Old Conway Design
Overlay District

DESIGN REVIEW BOARD MEETING

Togni Outbuilding/Garage Review - 411 Oliver St

North Elevation

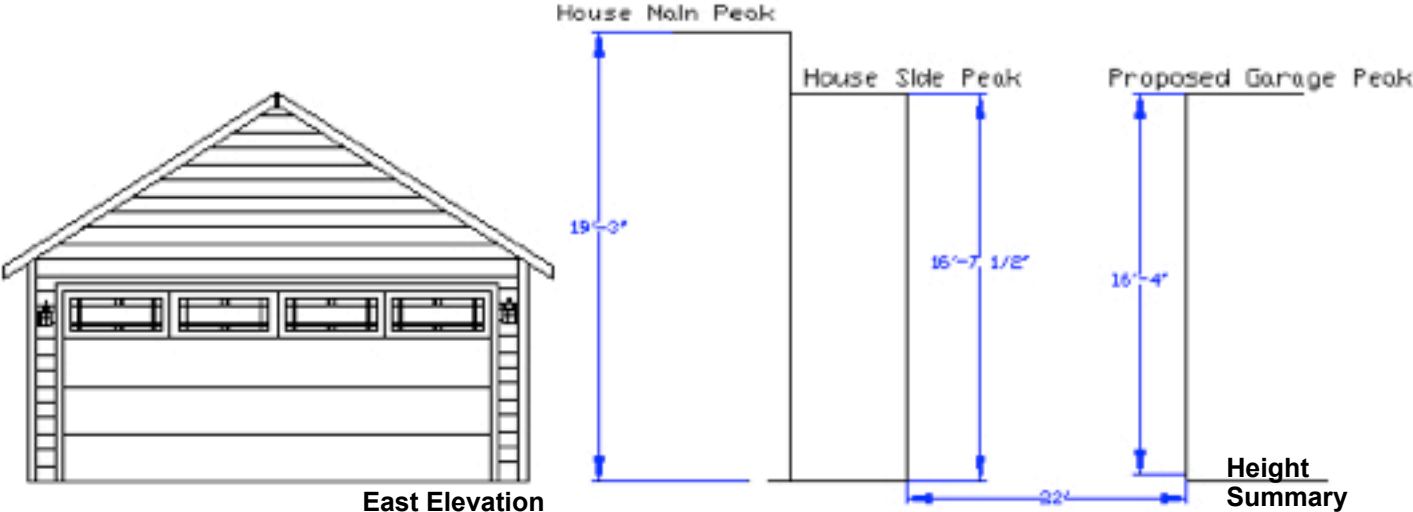
Height: The average heights of eaves and cornices in a neighborhood. Also, the first floor elevation / height relationship. The residence's tallest gable is 19'-3" in height. The lesser side gable is 16'-7". The overall height of the outbuilding will be approximately 16'-4". This height is acceptable in relation to the home. The existing outbuilding is approximately 14 feet in height.

Façade, wall area, rhythm: Facades shall be compatible with surrounding historic structures in proportion of wall to opening area. Window and door openings should correspond to the rhythm and proportion on existing structures. Generally doors and windows should be proportioned in a range of 25-40% of the total surface area. The supplied drawings show 2 windows and a door on the south elevation. Since this is an outbuilding a lesser degree of window and door openings is appropriate. The majority of the structure will be located behind a privacy fence, therefore, the number of windows and doors as shown can be seen as appropriate.

Lighting: Any new lighting should be inward, downward, and shrouded so as to stay within the bounds of the property. Proposed light fixtures as shown would match the appropriate style and would appear to be properly shrouded.

Architectural Details, Siding, and Bricks: – Eaves, brackets, dentils, cornices, molding, columns, trim, etc. Proposed outbuilding siding is a cement material board such as Hardiboard. The residence has open rafter tails although they are obscured by gutters. Open rafter tails might be appropriate for the outbuilding and would add to the traditional design of the outbuilding.

1. Garage/Outbuilding shall be generally constructed as submitted.
2. The front setback of the garage shall line be generally the same as the exiting garage front setback.
3. Efforts shall be made to preserve all significant trees within the affected construction area.
4. Door, window trim, and detailing shall be in a craftsman style.
5. Open rafter tails shall be utilized.
6. Fiber cement siding such as hardiboard is encouraged.
7. Roof shall be asphalt composition.
